**CITY OF MIDDLETOWN
ECONOMIC & COMMUNITY DEVELOPMENT AND PLANNING
COMMITTEE MEETING AGENDA
JULY 21, 2026 - 6:30 PM**

RE: 2-7 Orange Terrace
Section 33, Block 4, Lots 2-7
City of Middletown
Our File #21-054E

This narrative is submitted in support of the application by Orange Terrace Properties, LLC for approval of a minor subdivision involving properties identified as SBL 33-4-2 through 33-4-7, located on Orange Terrace in the City of Middletown.

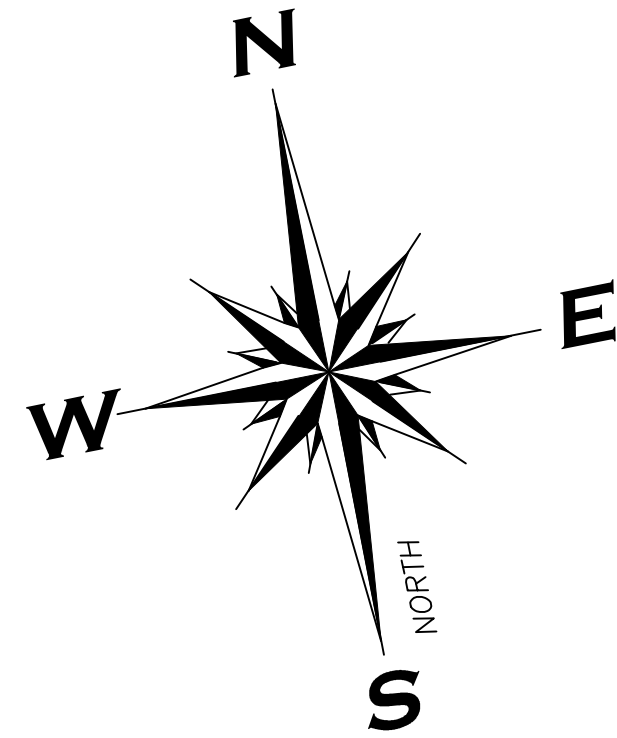
A key concern identified in the Common Council's denial dated December 3, 2024, was the presence of a retaining wall—particularly an approximately 11-foot-high wall located near the boundary between Lots 2 and 3, which was viewed as having potential adverse aesthetic and neighborhood impacts.

In response, the current subdivision layout and site design have been revised to address these concerns. As reflected in the updated site plan, grading and lot configuration have been adjusted to reduce the need for significant retaining wall structures and to minimize height and visual impact wherever feasible. Where retaining walls remain necessary due to existing topography, they are designed to be lower in height, appropriately set back, and integrated into the site with consideration for adjacent properties and neighborhood character. These modifications are intended to eliminate or substantially mitigate the concerns previously raised by the Council.

JMH	4/6/26	REDUCED RETAINING WALL TO 4'.
JMH	12/2/24	REVISED AS PER COMMON COUNCIL COMMENTS
JMH	10/14/24	REVISED AS PER PLANNING BOARD COMMENTS
JMH	10/10/24	REVISED AS PER PLANNING BOARD COMMENTS
JMH	6/27/24	REVISED AS PER PLANNING BOARD COMMENTS
JMH	3/6/24	REVISED AS PER CPL COMMENTS DATED 3/5/24
TLM	1/17/24	REVISED AS PER CPL COMMENTS DATED 1/15/24
JMH	11/8/23	REVISED AS PER CPL COMMENTS DATED 10/6/23
JMH	9/22/22	REVISED SUBDIVISION
JMH	12/21/21	REVISED TURNAROUND
JMH	11/1/21	REVISED WATER SERVICE TO 1"
JMH	7/21/21	LOTS 2 & 3 ADDED TO PLAN
SYMB	DATE	ISSUED FOR
